NEW MEXICO  
ENVIRONMENT DEPARTMENT  
*Water and Waste Management Division*

March 25, 2008

**RE: FINAL DETERMINATION, CLASS 2 MODIFICATION REQUESTS  
WIPP HAZARDOUS WASTE FACILITY PERMIT  
EPA I.D. NUMBER NM4890139088**

Attachment 1 – changes to permit modification request

Figure N1-1  
 Typical Substantial Barrier and Bulkhead

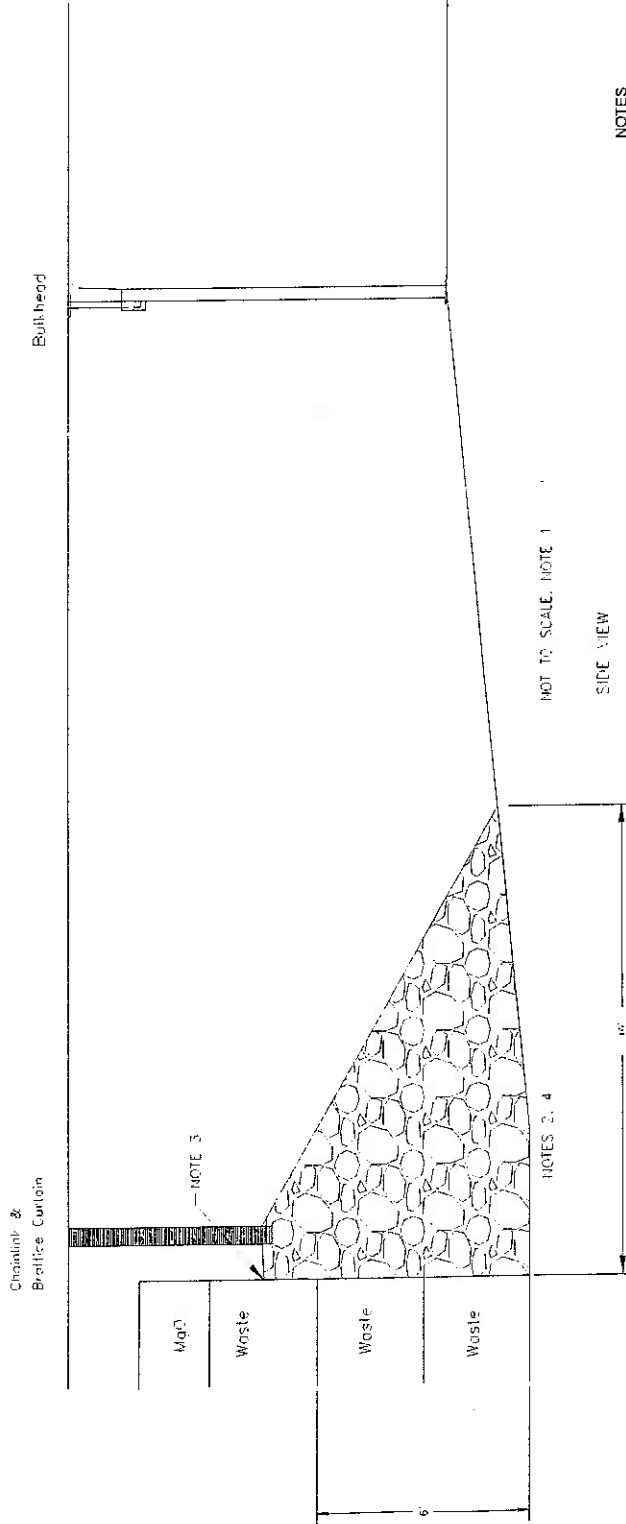
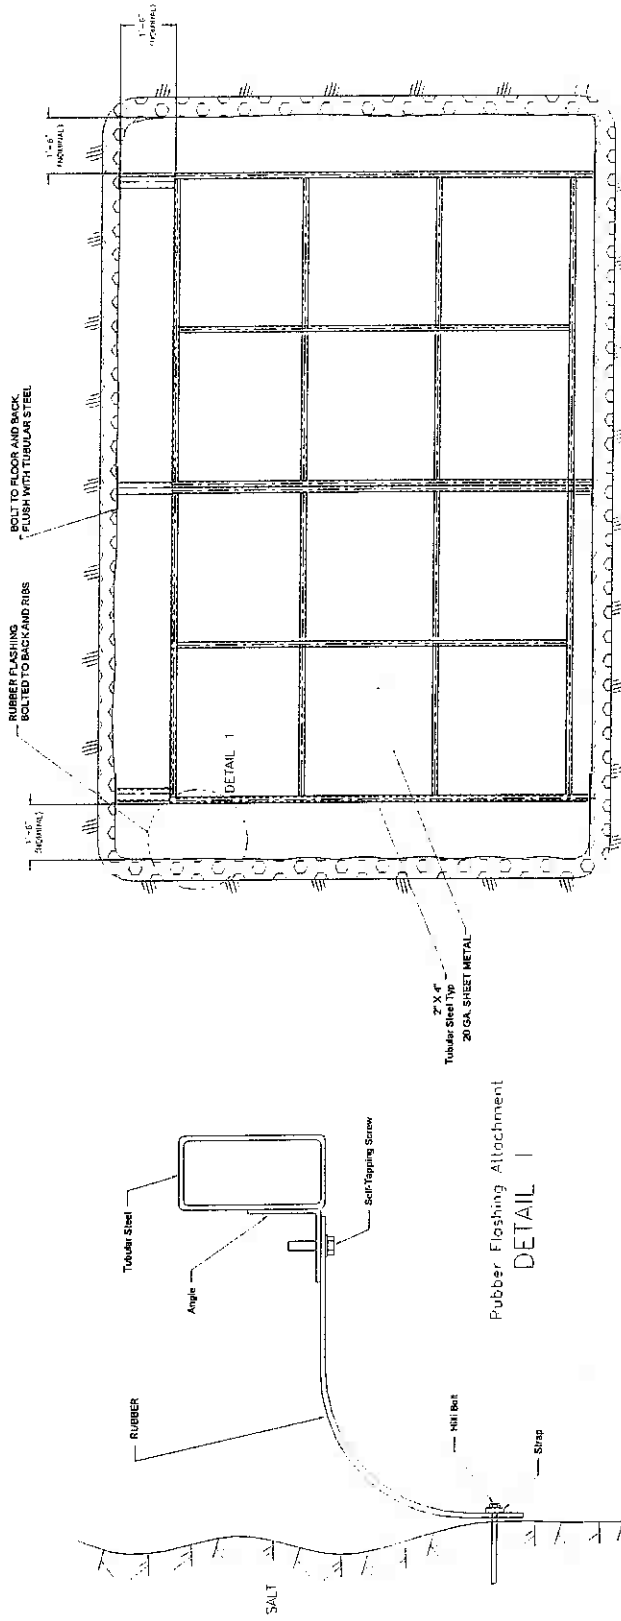
- Section N1-2 – added definition of “filled panel” consistent with Module I; clarified that monitoring would commence after installation of substantial barriers, bulkheads, and additional monitoring locations in filled panels; clarified where the “existing VOC monitoring lines” were specified in the Permit; clarified the term “back” and that the additional locations are in the access drifts.

18 The substantial barriers serve to protect the waste from events such as ground movement or  
19 vehicle impacts. The substantial barrier will be constructed from available non-flammable  
20 materials such as mined salt (Figure N1-1).
